PN Composite Ltd.

13 April 2014

High stress levels in columns

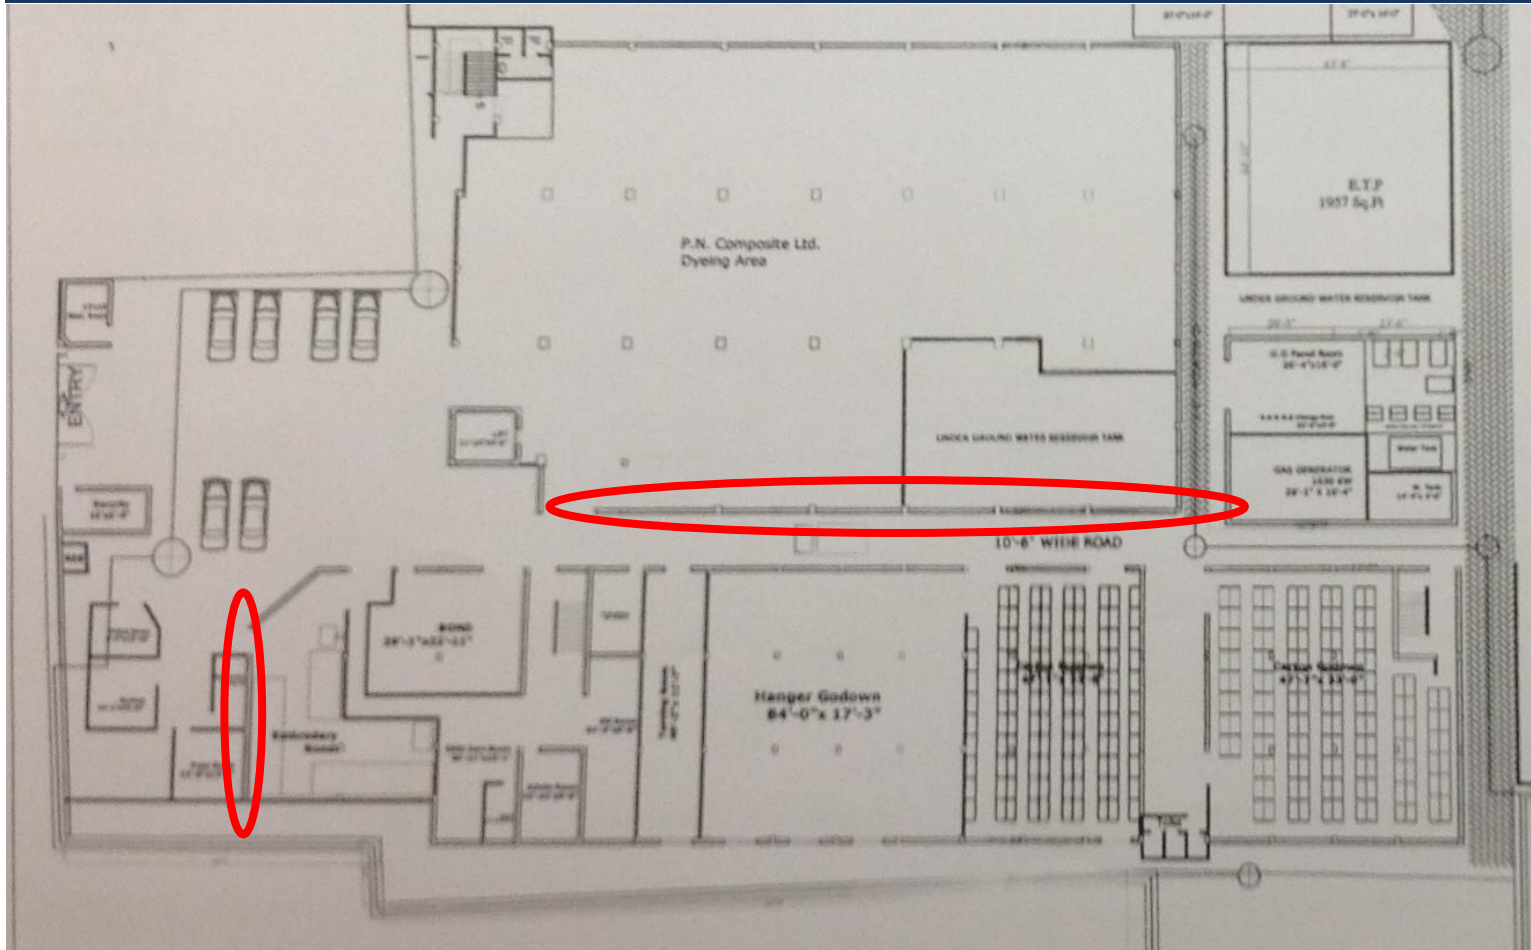
Outline calculations indicate the circled columns below are highly stressed under their current loading condition.

Item No.	Observation	Recommended Action Plan	Recommended Timeline
1	Stress levels in columns	Main Building: Temporarily cease all construction activities at Level 7. Ensure Level 6 remains unoccupied. Loading in the zone highlighted above to be limited to 1.5kN/m ² (Levels 2 to 5) and 2.5 kN/m ² (Level 1).	Immediate - Now
2	Stress levels in columns	Factory Engineer to review design, loads and stresses in all columns.	Immediate - Now
3	Stress levels in columns	Verify insitu concrete stresses either by 100mm diameter cores or existing cylinder strength data for cores from 4 columns. Verify grade of steel reinforcement used.	Immediate - Now
4	Stress levels in columns	A Detail Engineering Assessment of entire Main Building to be commenced - see attached Scope.	Immediate - Now
5	Stress levels in columns	Detail Engineering Assessment to be completed for complete building.	6-weeks
6	Stress levels in columns	Make structural alterations as advised by Engineer.	6-weeks

Cracking in corbel column

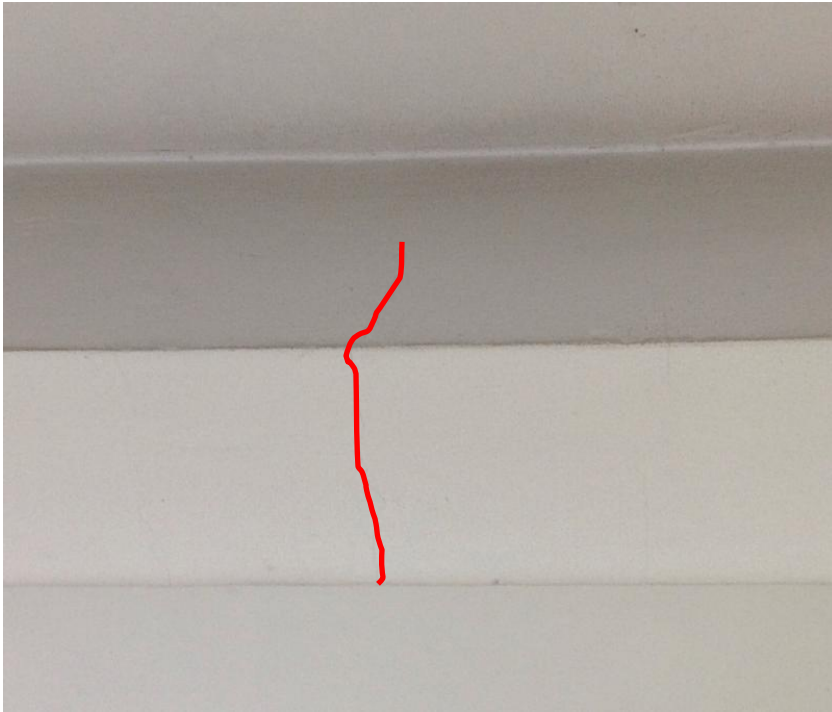
Cracking was observed from Level 2 in the corbel column.

Item No.	Observation	Recommended Action Plan	Recommended Timeline
9	Cracking in corbel column	Factory Engineer to investigate the corbel cracking, as part of the Detail Engineering Assessment (see Item 1)	6-weeks
10	Cracking in corbel column	Make any necessary structural alterations as directed by the Engineer.	6-months
11	Cracking in beams and slabs: mid-span and at movement joint	Factory Engineer to investigate if the cracking has any structural significance, as part of the Detail Engineering Assessment (see Item 1).	6-weeks
12	Cracking in beams and slabs: mid-span and at movement joint	Carry out any remedial work as directed by the Engineer.	6-months
13	Discrepancies between structural drawings and actual observations	Factory Engineer to update the drawings to “as constructed” status to reflect the actual site dimensions and column locations as part of the Detail Engineering Assessment. The drawings should show the integrated building (dyeing, garments and offices).	6-weeks

Water tank slab alteration

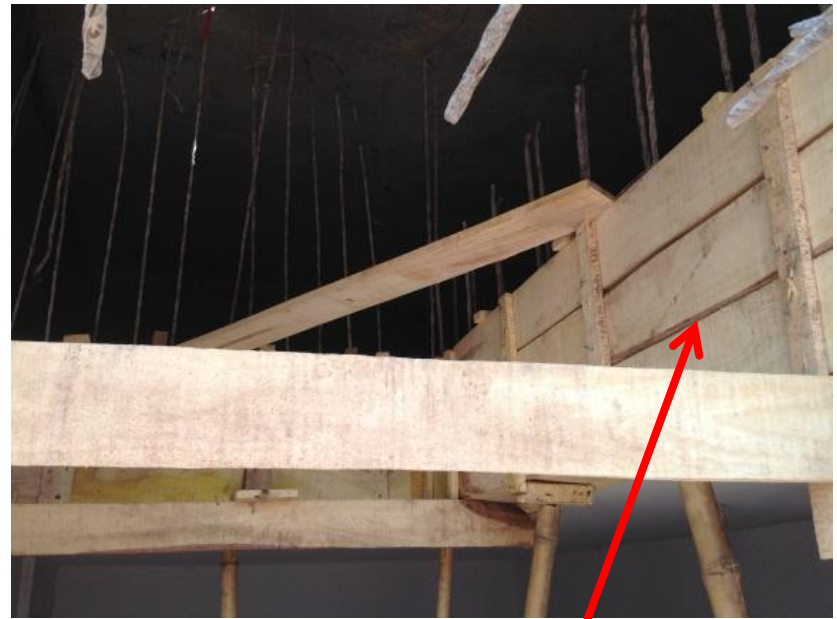
A portion of the water tank slab is being raised to create head-room for stair access onto the roof.

Item No.	Observation	Recommended Action Plan	Recommended Timeline
14	Water Tank slab alteration	Factory Engineer to check construction to ensure compliance with design intent.	6-weeks
15	Water Tank slab alteration	Make any alterations as directed by the Engineer.	6-weeks
16	Apparently non-engineered structures	Factory Engineer to check the capacity of the lightweight roofs to Shed Buildings and to Main Roof areas under horizontal and vertical loading, and make any necessary alterations.	6-months
17	Apparently non-engineered structures	Factory Engineer to check the capacity of the masonry wall panels under horizontal and vertical loading and make any necessary alterations.	6-months
